DEALER NOTIFICATION – SAFETY RECALL

Subject: Demonstration / Delivery Hold / Stop Sale
Field Action No.: 11-101

Field Action 11-101 --- Customer and Dealer Notification **SAFETY RECALL** – Incorrect Seat Belt Installation

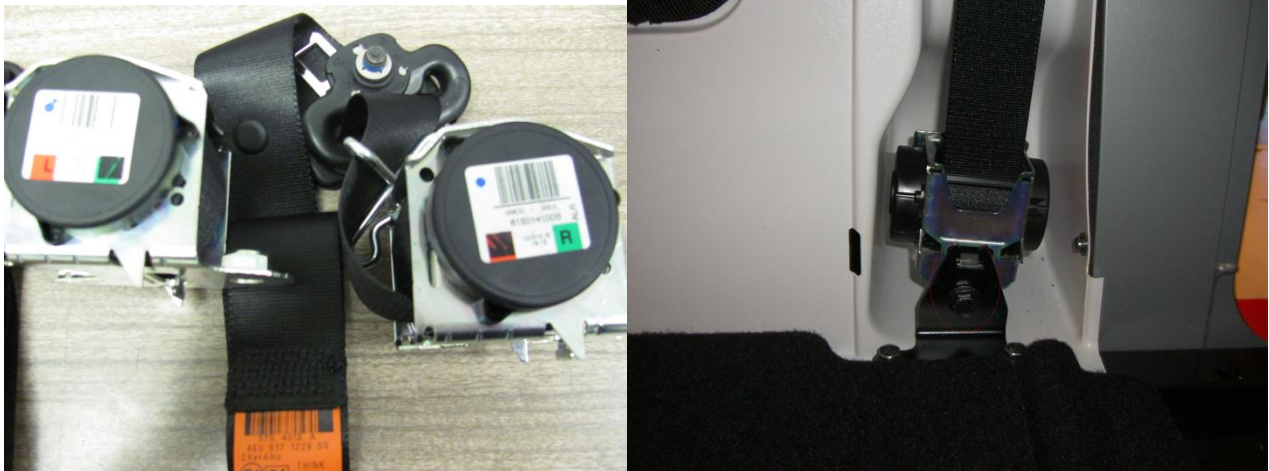
THINK North America has determined that front seat belt subassemblies may have been incorrectly installed in some 2011 THINK City model vehicles. The driver seat belt retractor assembly marked LHS may have been installed on the passenger-side of the vehicle and the passenger seat belt retractor assembly marked RHS may have been installed on the driver-side of the vehicle.

For this repair procedure you must first inspect the vehicle to make sure that it has seat belt subassemblies marked RHS – and – LHS and, then you must confirm their proper installation in the correct side of the vehicle. If the installation is incorrect you must remove the seat belt subassemblies and properly install them in the correct side of the vehicle.
